Product Change Notification

Change Notification #: 107002 - 00
Change Title: Intel PRO/1000 PT Quad Port Bypass Adapter,
EXPI9014PTBLK MM#876697
and EXPI9024PTBLK MM#876699,
Dewey Beach ByPass & NIF

**Remove Heat Sink and Clip, and related
changes to roll the EEPROM, TA and PBA**

Date of Publication: November 21, 2006

Before picture with Heat Sink and Clip

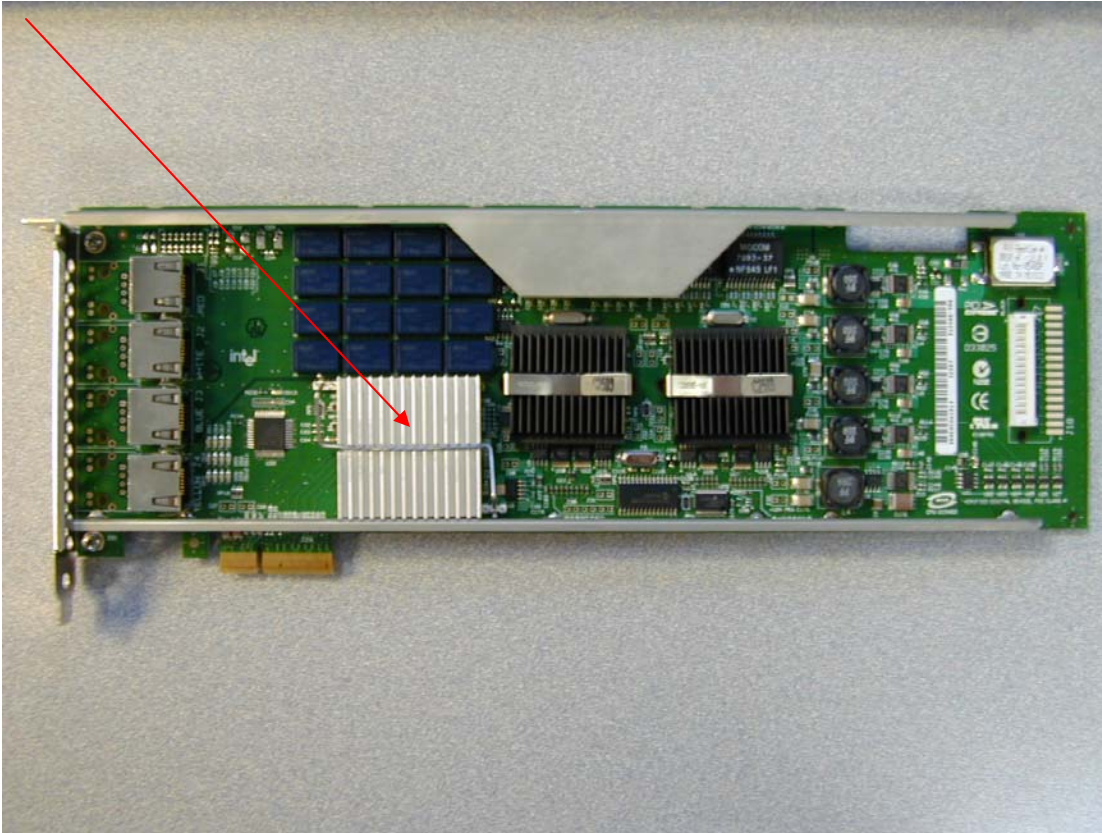
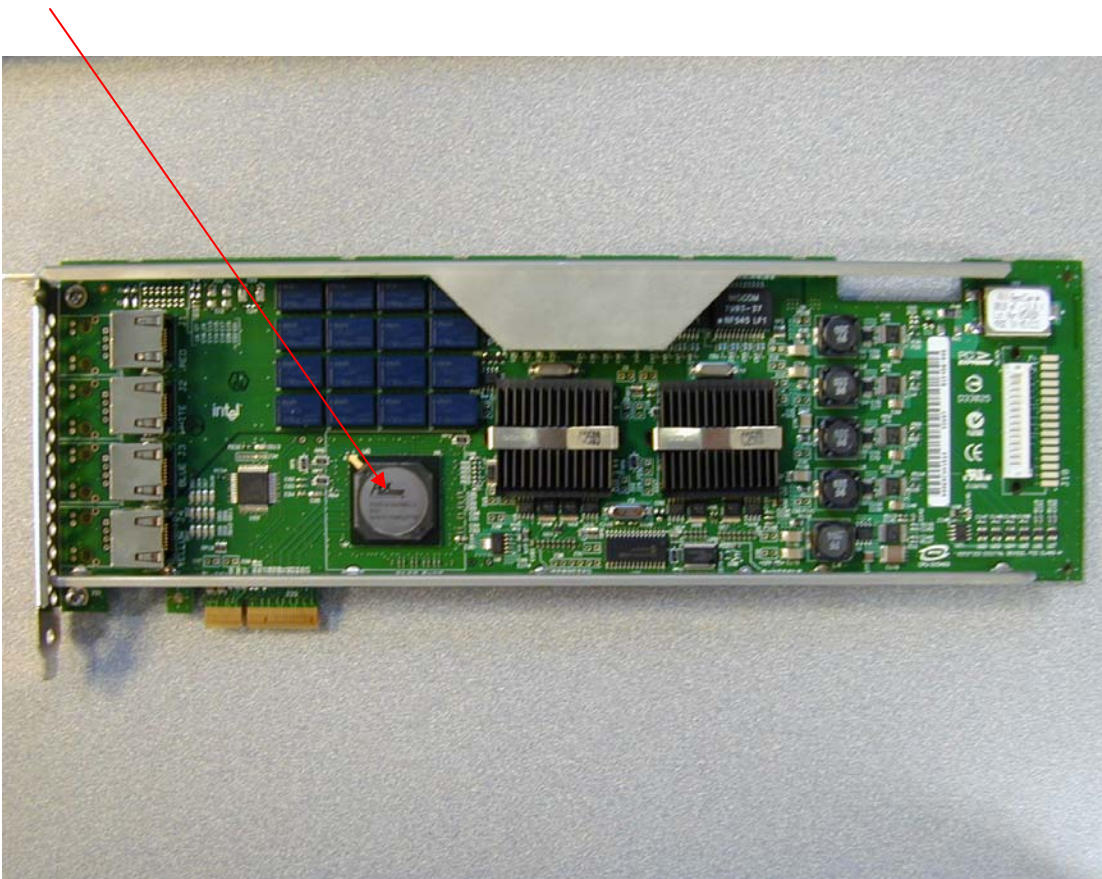
- Intel will remove one heat sink and clip from the PLX Bridge switch, as noted in the pictures below.

- The EEPROM, TA & PBA numbers will also roll.

The Heat sink and clip are being removed because they are unnecessary. This will not change the performance of the product.

Testing on the Dewey Beach PLX switch without the heat sink showed the following results; the highest no air flow case temperature recorded with no heat sink was 65 degrees Centigrade. Customers who wish to obtain more testing data, can contact their local Intel Field Sales representative.
